CITY OF LAS VEGAS 2050 MASTER PLAN – Chapter 4, Trails and Bike Street Map

PROPOSED AMENDMENTS

23-0572-GPA1 proposes to amend the following maps and associated material contained below. Note that amendments to the tables for Identified Capital Improvements for Transportation in Chapter 5 will be amended and updated as part of a future General Plan Amendment:

26- Torrey Pines Drive

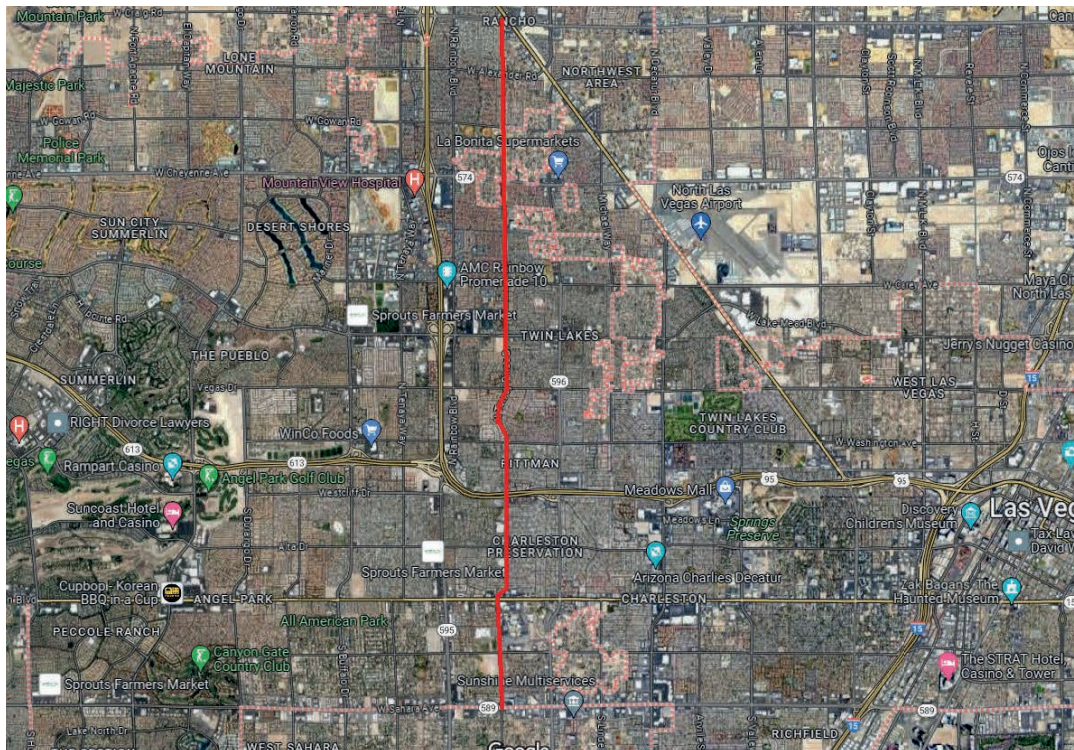
Delete and Amend Project 26- Torrey Pines improvements - Shared Use Trail Designation, from Rancho to Sahara Avenue

Because Torrey Pines Drive is a collector for its length, it is the intent of the plan to align the modal function as a “bike street.” As it currently exists, the trail along Torrey Pines is greater than 80 percent incomplete. The development pattern along sections of Torrey Pines, consisting largely of existing small single family lots, in conjunction with limited right-of-way width, makes completion of the trail extremely implausible in the near to medium term. There is connectivity across US-95 in the form of an overpass, along with existing on-street bike lanes, so improved bicycle facilities may be appropriate in the future.

Staff recommends removal of the shared use trail designation to reflect the limitations of existing conditions and to not impede development in the future, with the future intent of adding a classification for a type of “bike street” facility.

27- Michael Way, Meadows Ln improvements

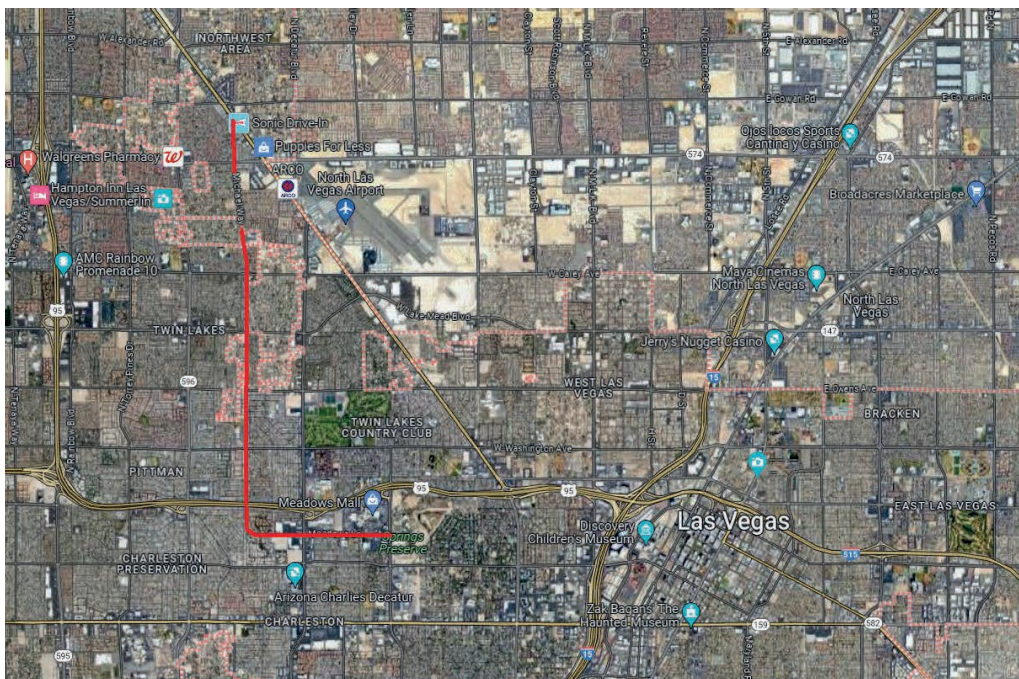
Delete and Amend Project 27 - Michael Way improvements - Shared Use Trail Designation, from Rancho to South Valley View Boulevard and Meadows Lane (entire length)

Because Michael Way and Meadows Lane are both collectors, it is the intent of the plan to align the modal function as a “bike street.” As it currently exists, the trail along Michael Way has many gaps and is greater than 80 percent incomplete, similar to Torrey Pines Dr. The development pattern along this section of Michael Way, consisting largely of existing small single family lots, in conjunction with limited right-of-way width, makes completion as a trail extremely implausible. In addition, there is currently no connectivity across US-95, with potential for adding a crossing limited in the near to medium term.

Staff recommends removal of the trail designation to reflect the limitations of existing conditions and to not impede development in the future, with the future intent of adding a classification for a type of “bike street” facility.

Add Shared Use Trail Designation to Stewart Ave, 6th Street to Nellis Boulevard

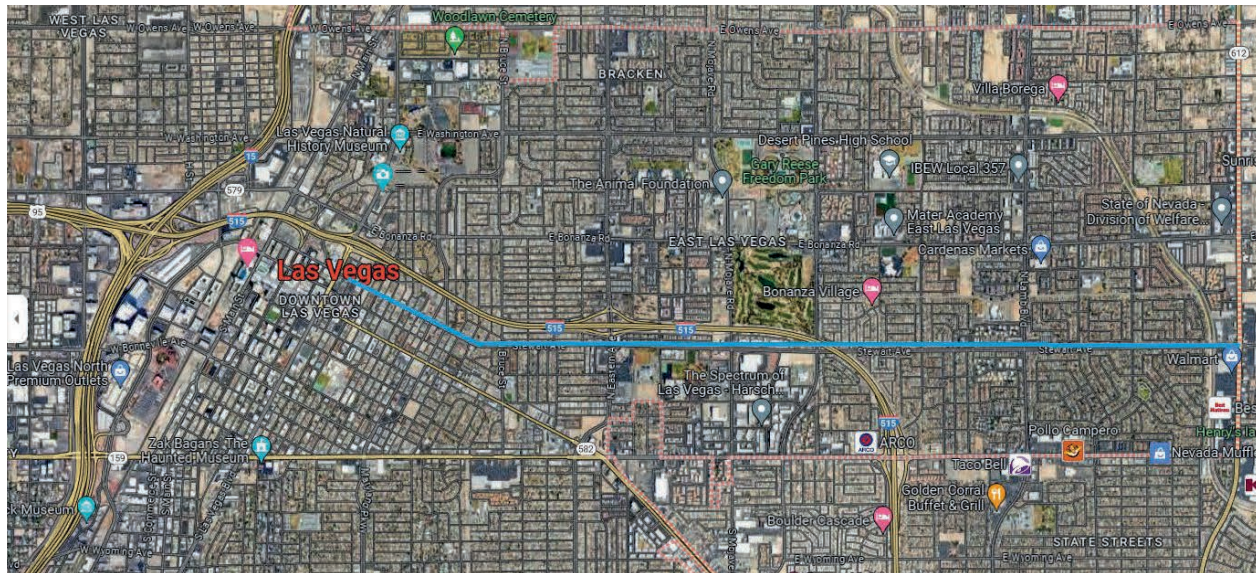
This addition would add Stewart Avenue, from 6th Street to Nellis Boulevard to the 2050 Master Plan Complete Streets Trail Map as a Shared-Use Trail Urban Path/Cycletrack. The City received a grant from the Rebuilding American Infrastructure with Sustainability and Equity (RAISE) program within the US Department of Transportation in 2022. The grant awarded \$23.9 million for the installation of a two-way protected cycle track, sidewalk widening and obstruction removal to meet or exceed ADA accessibility guidelines, upgraded lighting, bus stop improvements and amenities, the addition of significant landscaping and street trees, prediction technologies for cyclists and pedestrians near intersections, and a corridor-wide speed limit reduction. The project will redevelop a neighborhood corridor to better serve the residents in East Las Vegas. Staff are requesting this change to the Complete Streets Trails map to ensure consistency with the Master Plan.

Add Off-Street Trail Along Toque Trail Alignment and amend equestrian trail designation:

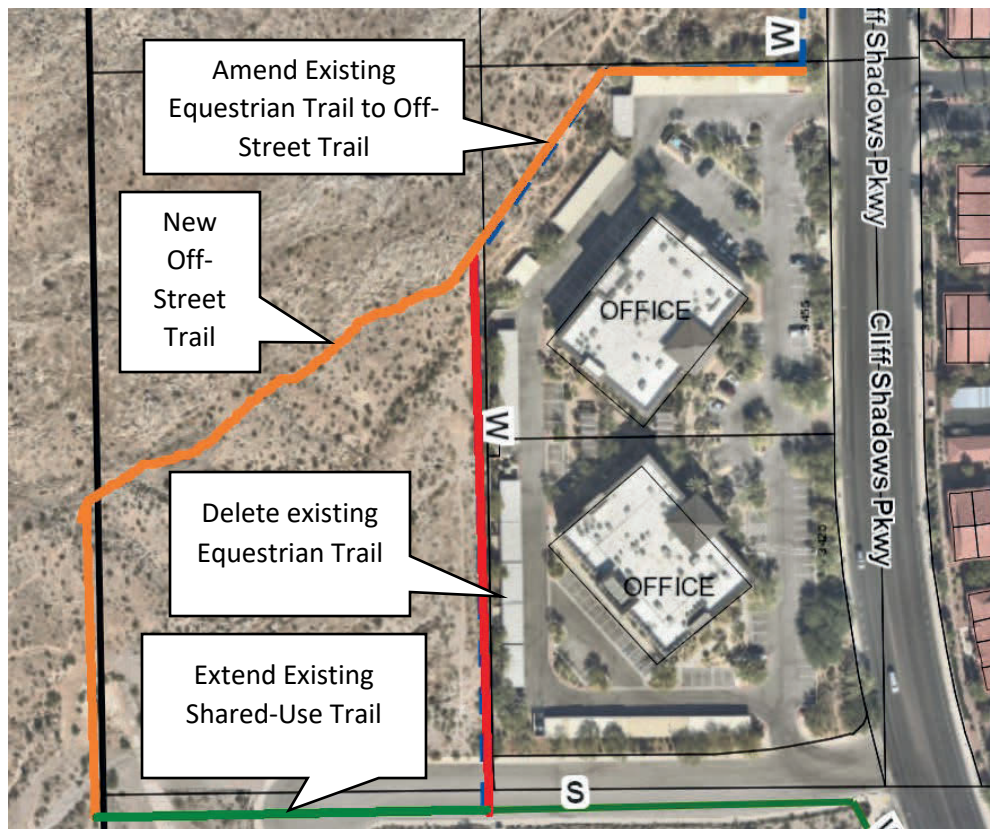
Add the portion of the Toque Trail that exists within City limits to the 2050 Master Plan Complete Streets Trail Map as an Off-Street Trail and designate the portion of existing equestrian trail designation to Off-Street that runs through hilly and rugged terrain. The City has applied for a \$100,000 grant from the Recreational Trails Program to develop a design for this trail that is currently regularly used but not officially recognized as a trail. This trail connects to a larger trail network outside the City on BLM land, but proximity to existing development means there is potential for this connection to be broken if the trail is not preserved as a trail alignment. Additionally, this would connect to the existing Cliff Shadows Pkwy equestrian trail designation from Buckskin Cliff Shadows Park to Trigono Hills Park, integrating it into the citywide trail network. The existing equestrian trail alignment paralleling the adjacent parcels to the east (13712301023 and 13712301024) will be deleted and the existing shared use trail on Buckskin Avenue will be extended west, connecting to the trail.
